CIRCLE SQUARE PLOTS 2, 3 + 4
(FORMERLY KNOWN AS BBC SITE)
OXFORD ROAD, MANCHESTER

Non-Material Amendments
April 2020

4.1 Planning Approved Drawing - Basement

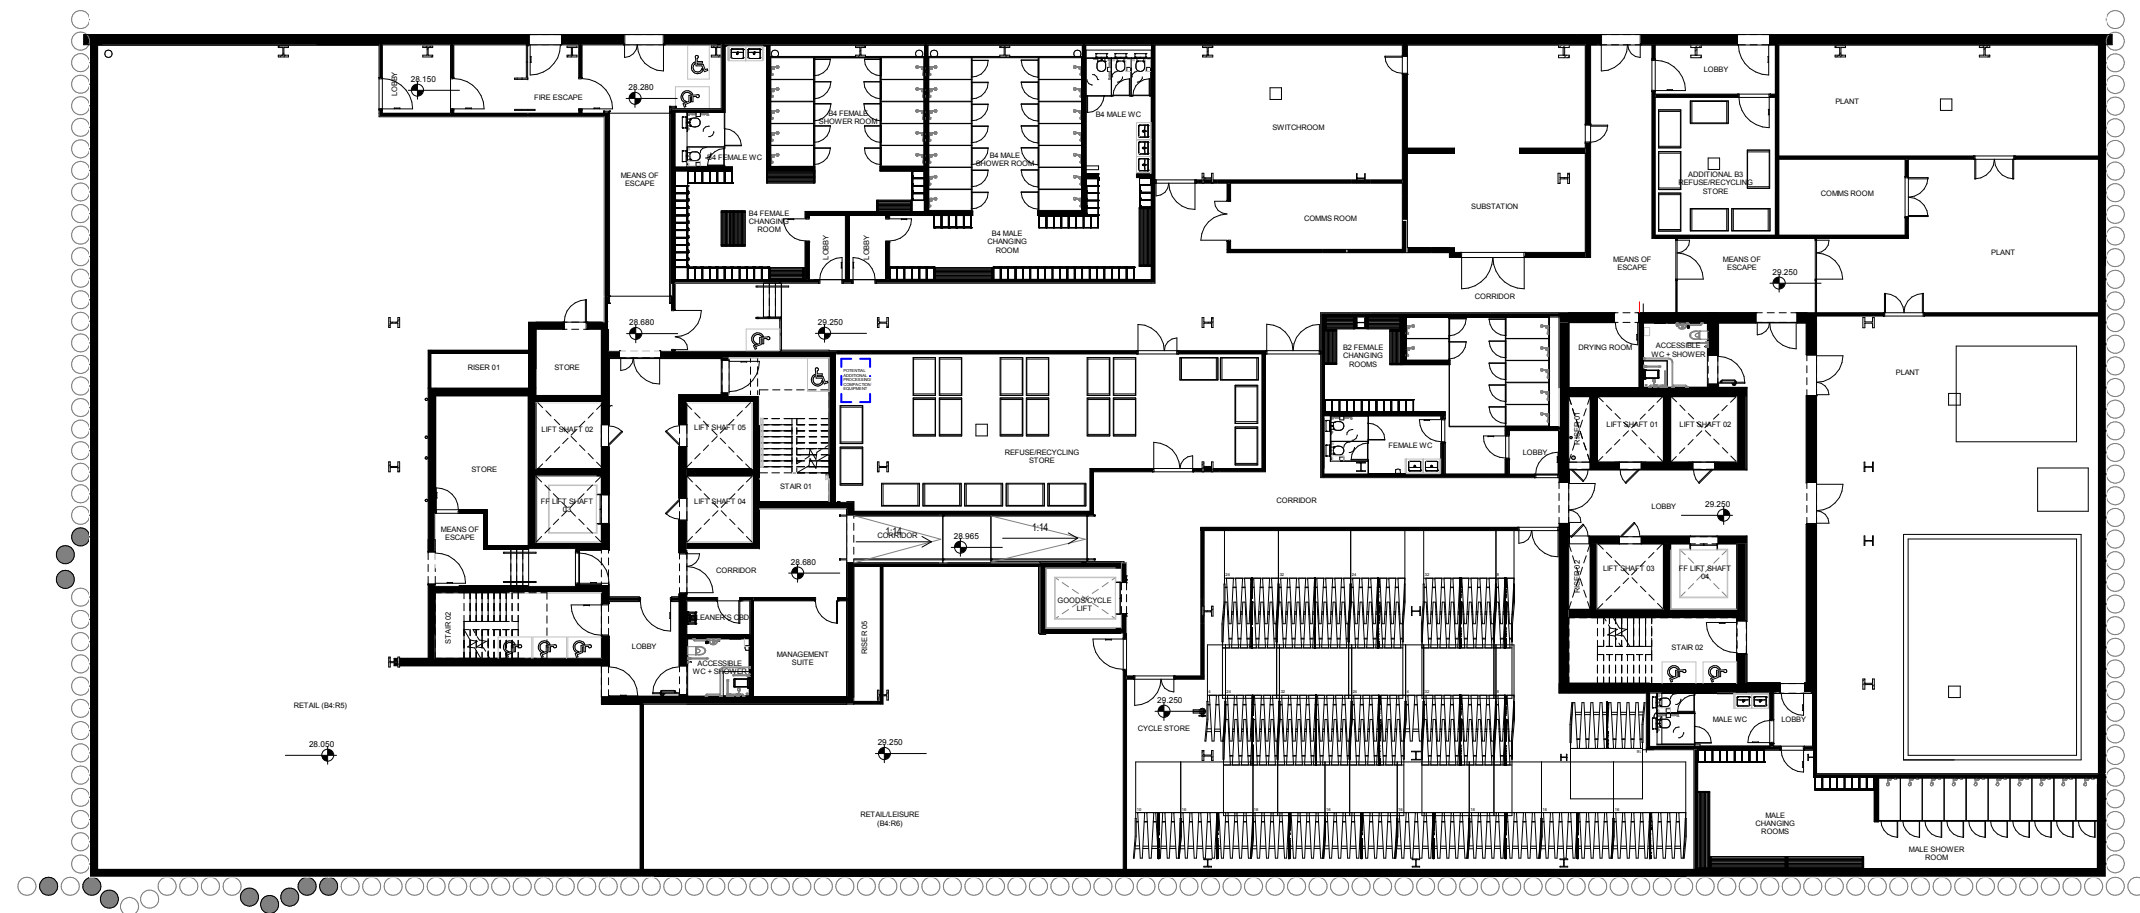
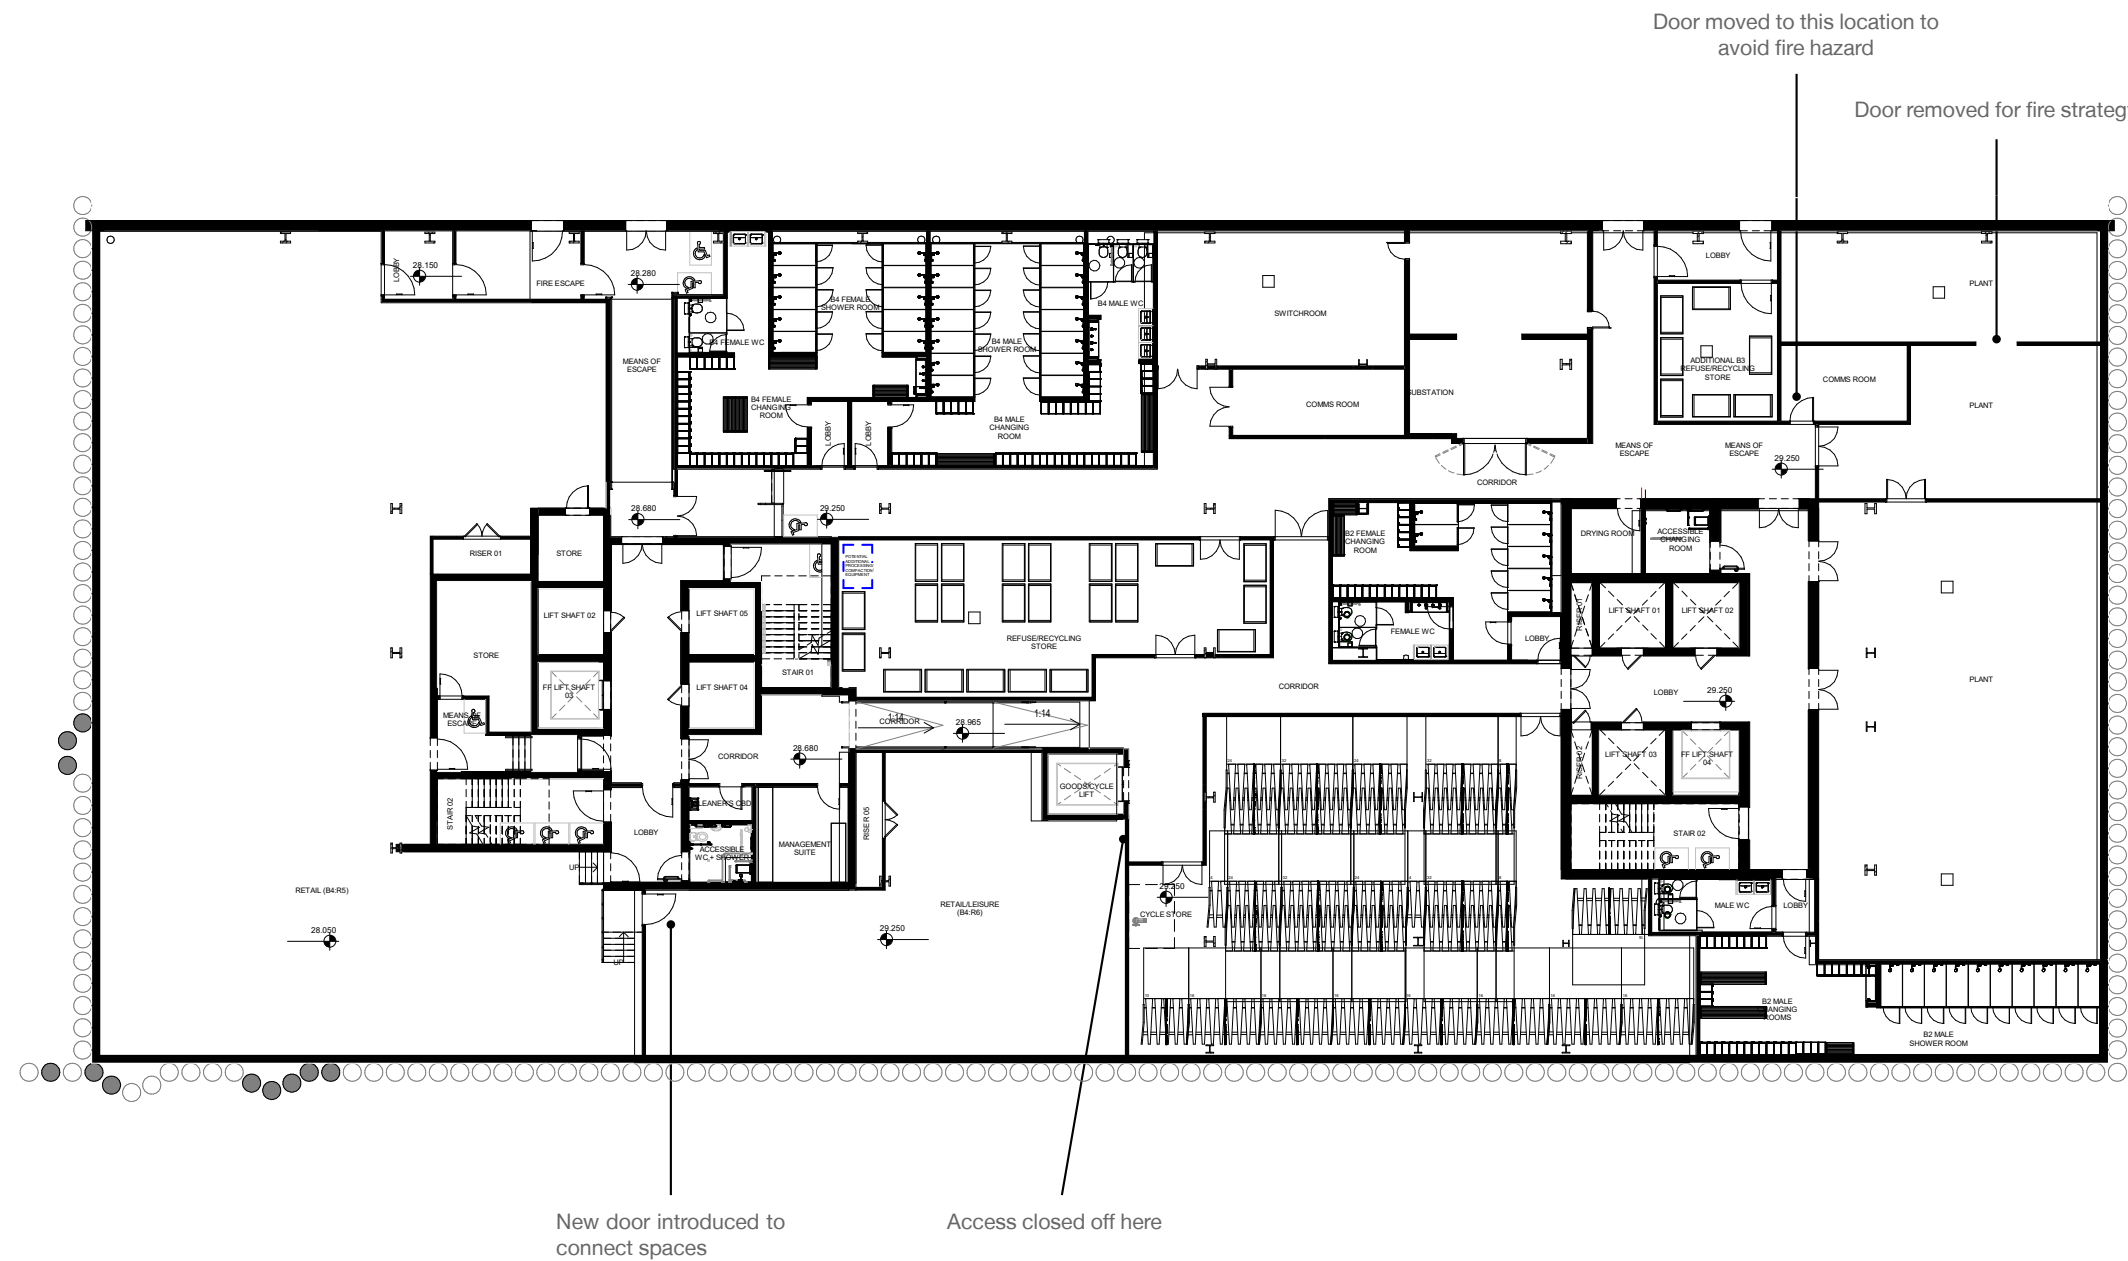
Reconfigured internal access to units and layout changes to the substation, management suite, and accessible changing room.

4.2 Planning Approved Drawing - Ground Floor

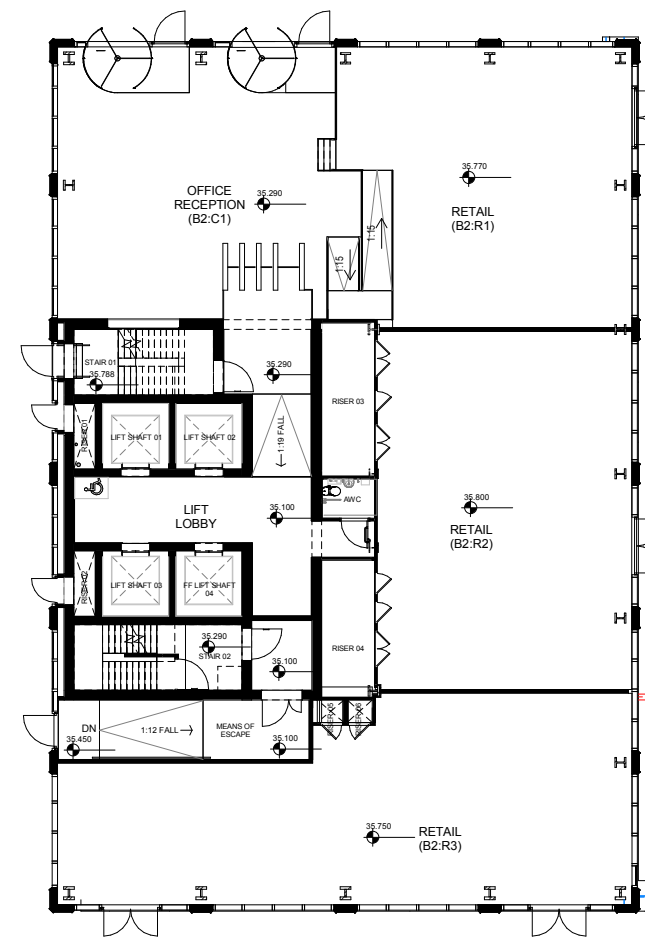
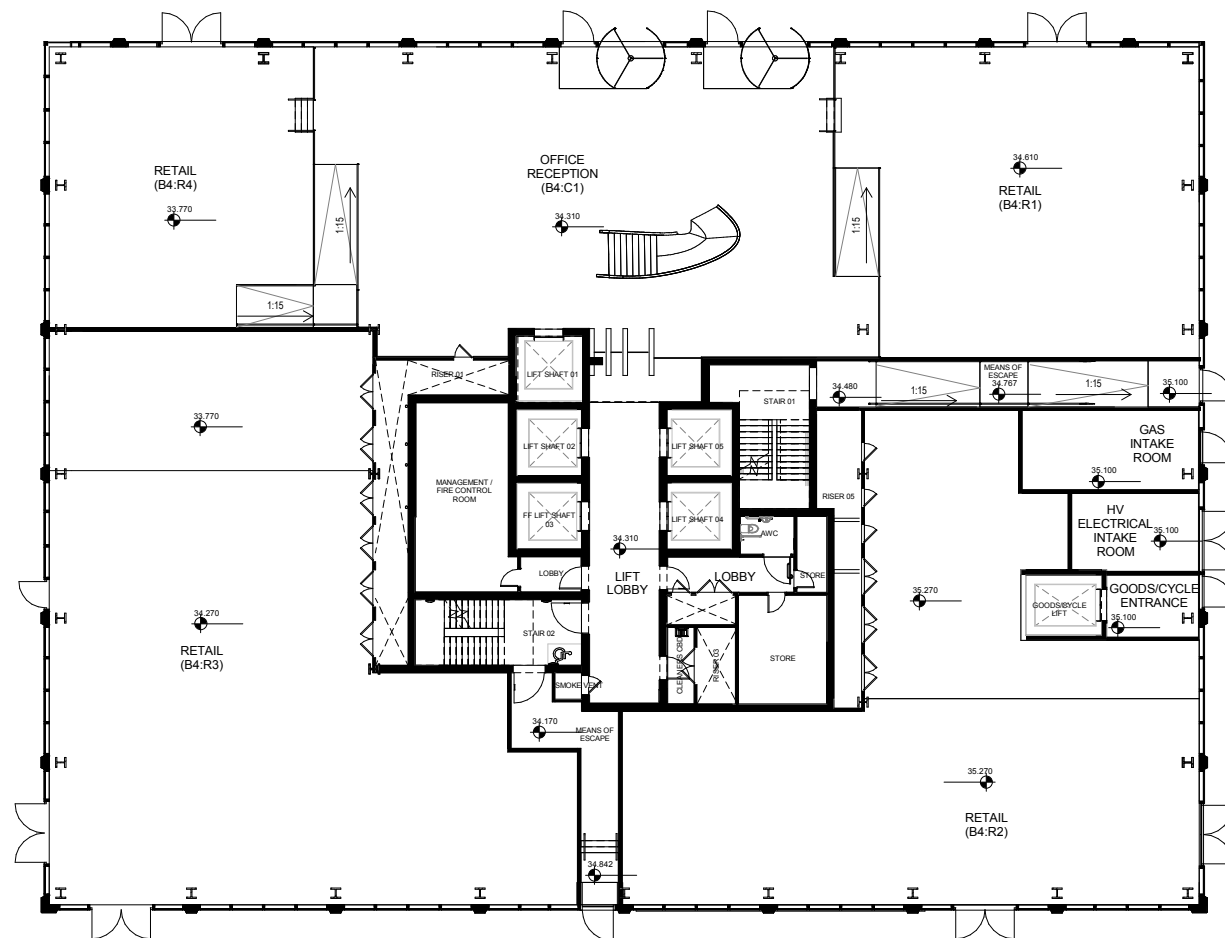
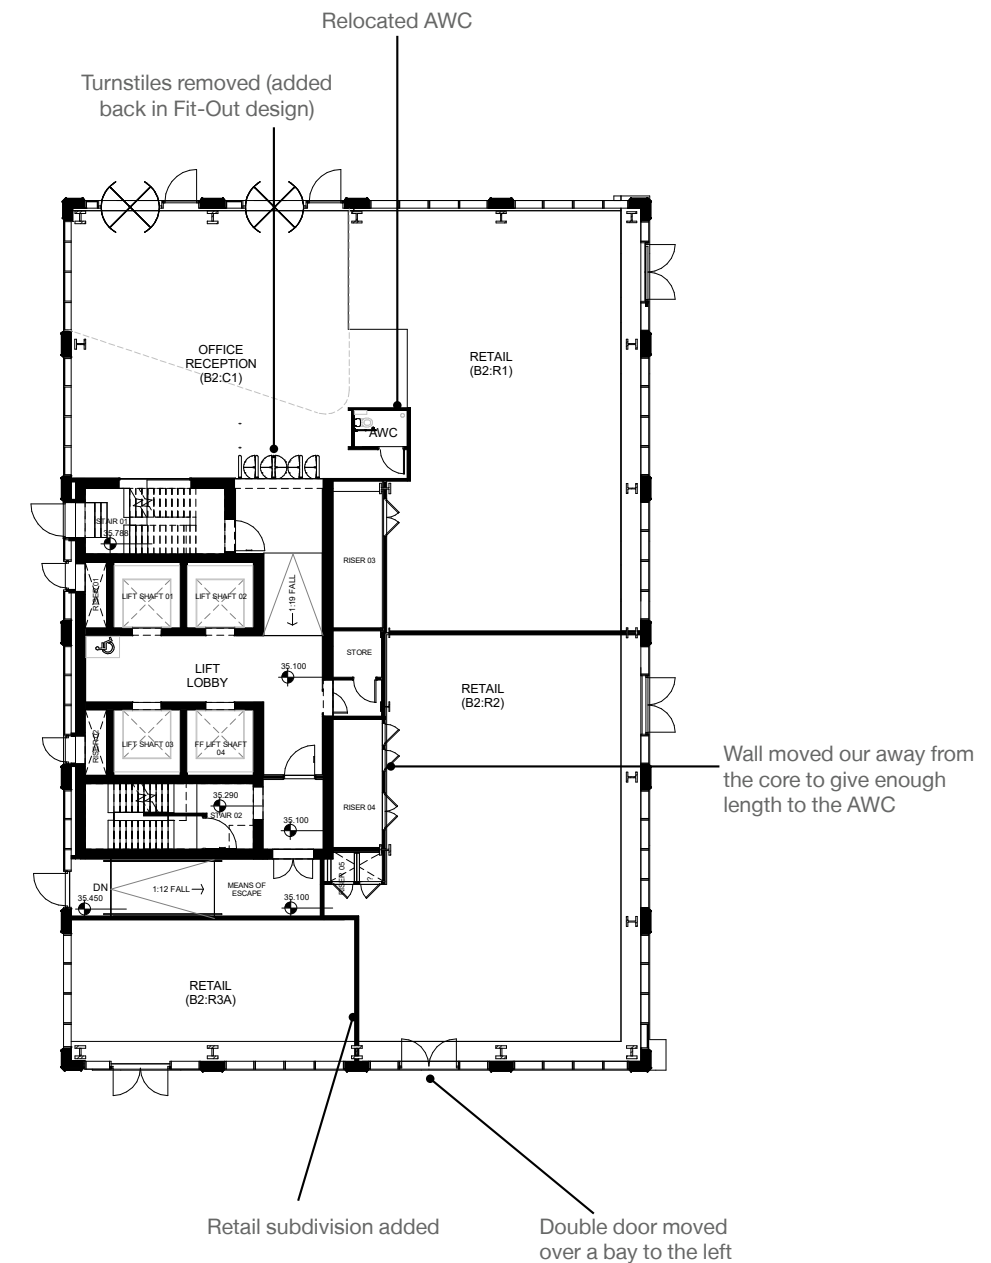
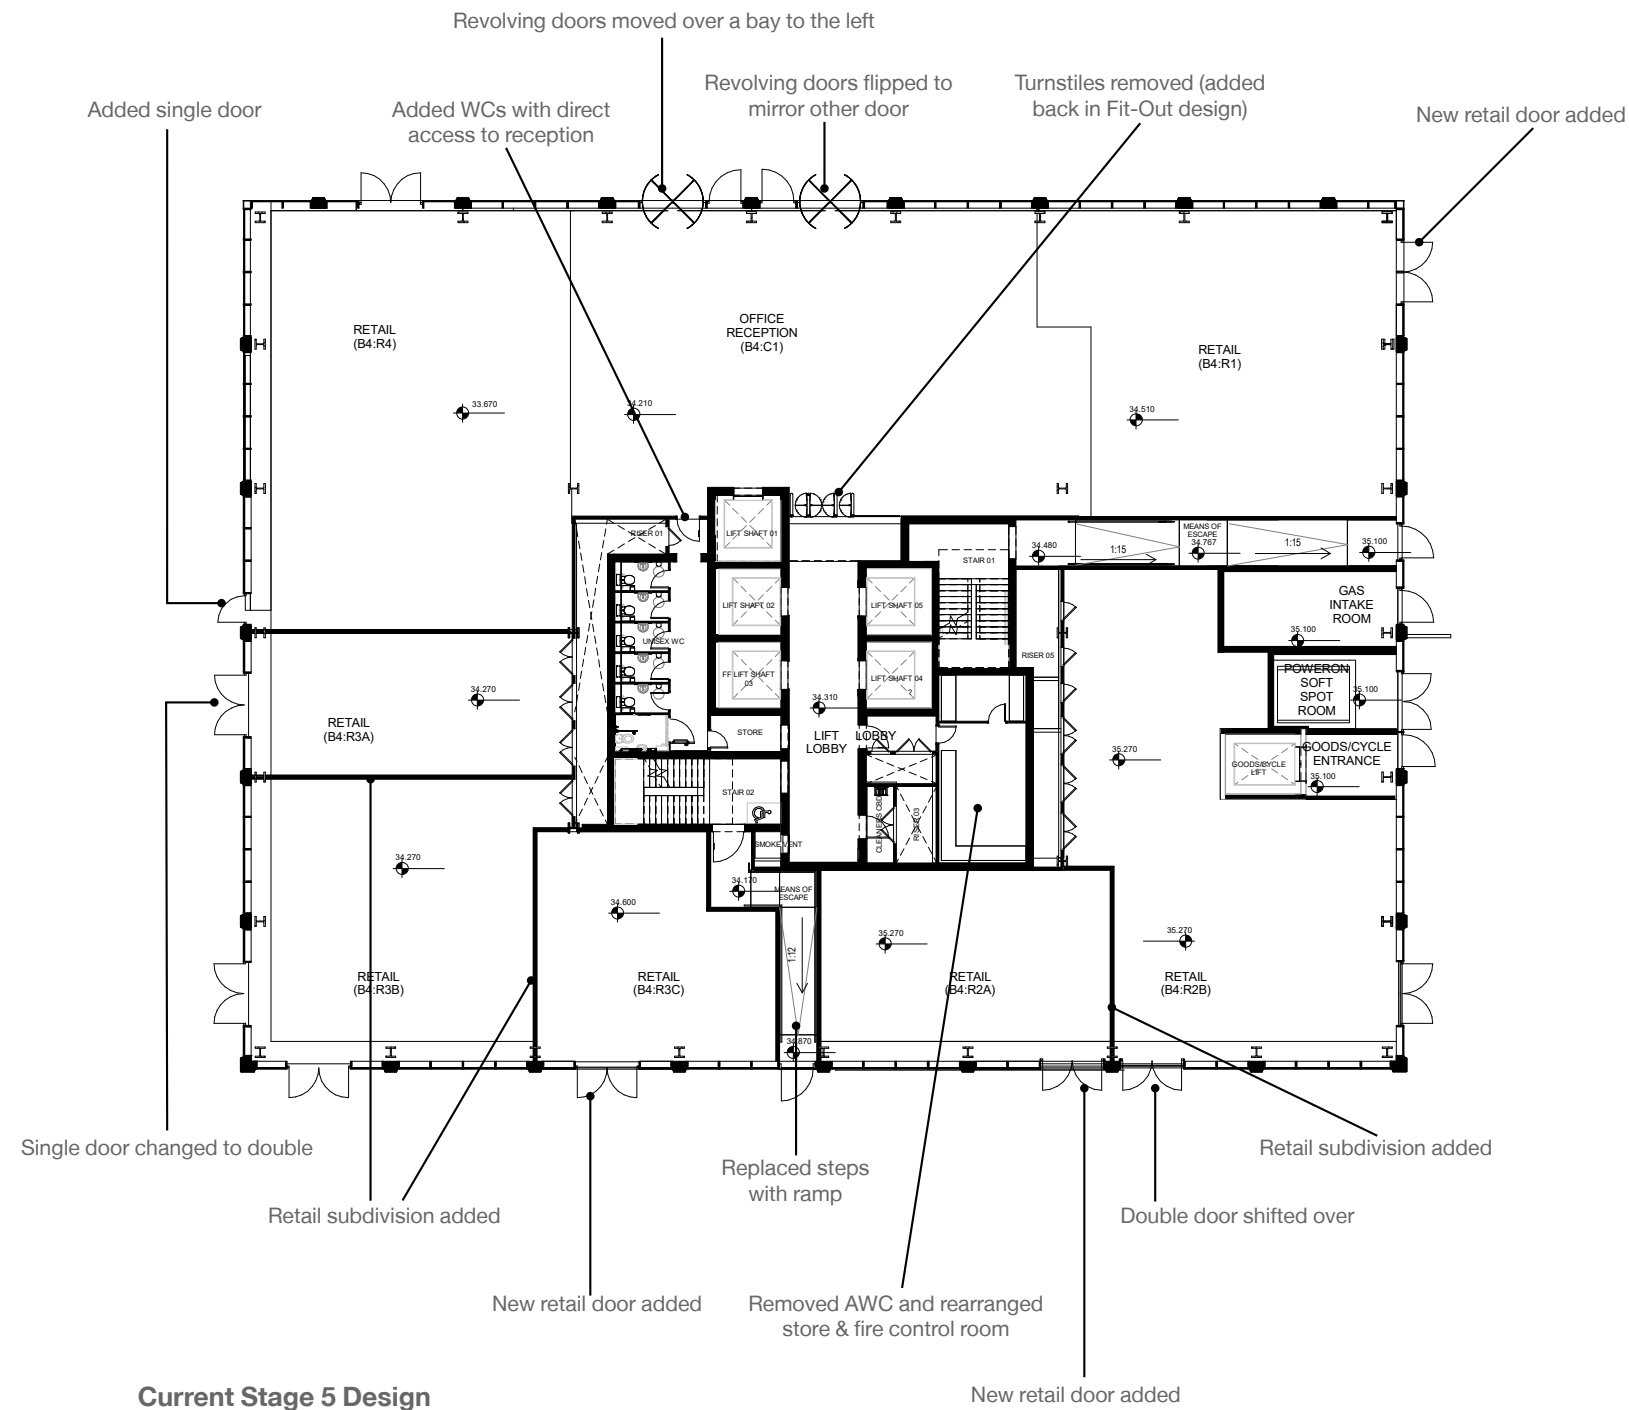
Updated retail unit layouts following tenant requirements leading to additional external doors around the perimeter. Following fit-out design developments, WCs have been added directly from the reception area to simplify access through the core.
